HARRIS PLACE SUBDIVISION, RESUBDIVISION OF

LOT 1

APPLICATION NUMBER 13 DATE July 11, 2013
APPLICANT Harris Place Subdivision, Resubdivision of Lot 1
REQUEST Subdivision

DETAIL SITE PLAN

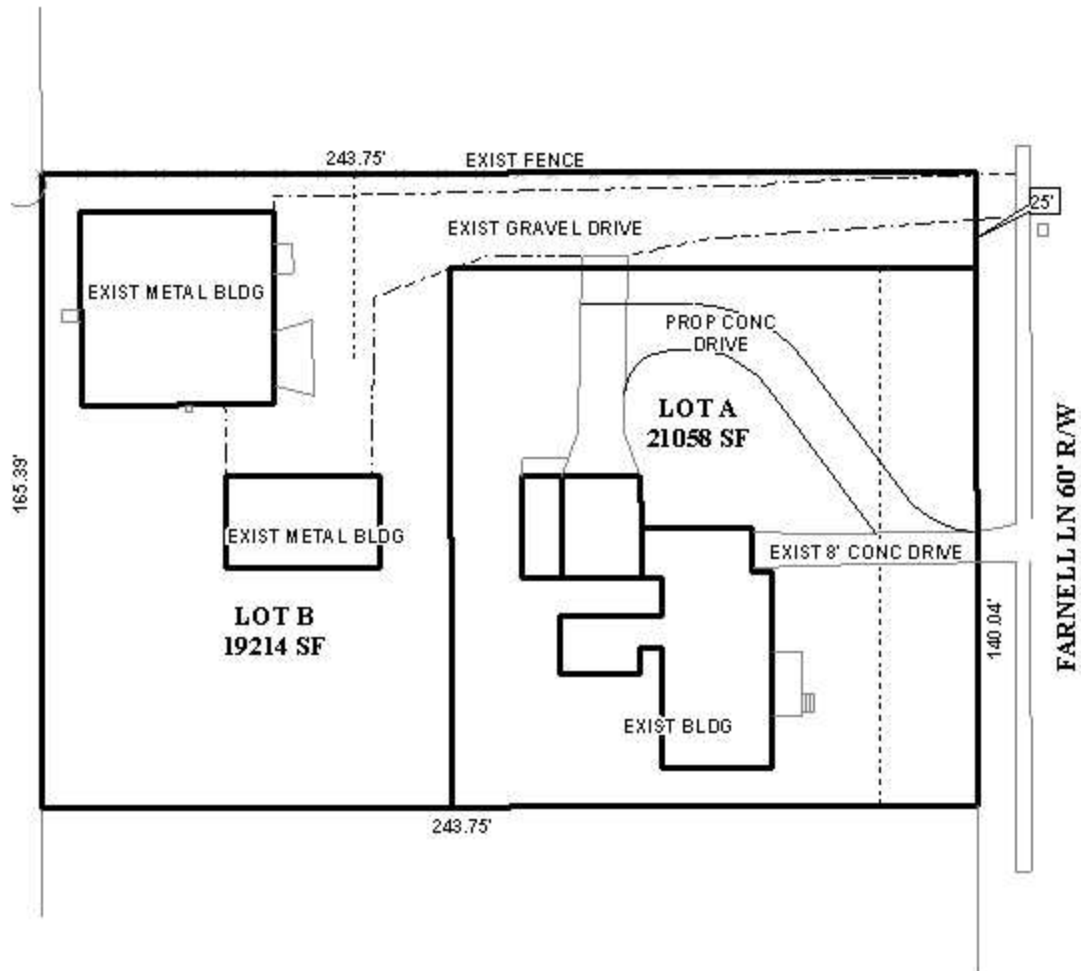
The plat illustrates the proposed 0.9 acre \pm , 2 lot subdivision which is located on the west side of Farnell Lane at the west terminus of Brossett Street, and is in Council District 4. The applicant states that the subdivision is served by both public water and sanitary sewer.

The proposed Lot B is a flag lot, and, while meeting the minimum width of 25 feet for a flag lot, the applicant did not provide any information stating unusual circumstance which may exist on the lot, or if there is a natural or pre-existing man-made barrier which may cause an undue hardship. Flag lots are generally not allowed, and there appears to be no Planning Commission

approved flag lots in the immediate vicinity of the site. As such, the proposed lot does not seem to satisfy the requirements of Section V.D.1. of the Subdivision Regulations.

The 25-foot minimum building setback line and the lot area sizes, in square feet, are depicted on the plat, and should be retained on the final plat, if approved.

The proposed lots have frontage along Farnell Lane, a minor street not provided with curb and gutter. As a means of access management, each lot should be limited to a single curb cut, to Farnell Lane with the size, location and design of all curb-cuts to be approved by Traffic Engineering and conform to AASHTO standards.

Due to the fact the site abuts residential property a 6' high 10' wide vegetation buffer or 6' wooden privacy fence will be required along the western perimeter of the site.

Based on the preceding, this application is recommended for holdover until the September 5, 2013 meeting, with revisions due by Monday, July 15, 2013 to address the following:

- 1) submission of a Planned Unit Development application, to include a tree and landscaping plan, for the purposed lot B;
- 2) submission of written documentation explaining the use of the two purposed lots and justification for a flag lot for lot B;

- 3) placement of a note on the final plat stating each lot shall be limited to one curb-cut to Farnell Lane, with the size, location and design to be approved by Traffic Engineering and conform to AASHTO standards;

- 4) placement of a note on the final plat stating that a buffer in compliance with Section V.A.8. of the Subdivision Regulations will be required;
- 5) compliance with Engineering comments (*The following comments should be addressed prior to review, acceptance and signature by the City Engineer: 1. Provide all of the required information on the Final Plat (i.e. signature blocks, signatures, certification statements, legal description, required notes). 2. Add a note to the Plat stating that storm water detention will be required for any future addition(s) and/or land disturbing activity in accordance with the Storm Water Management and Flood Control Ordinance (Mobile City Code, Chapter 17 , Ordinance #65-007 & #65-045). 3. Add a note to the plat stating that any work performed in the existing ROW (right-of-way) such as driveways, sidewalks, utility connections, grading,*
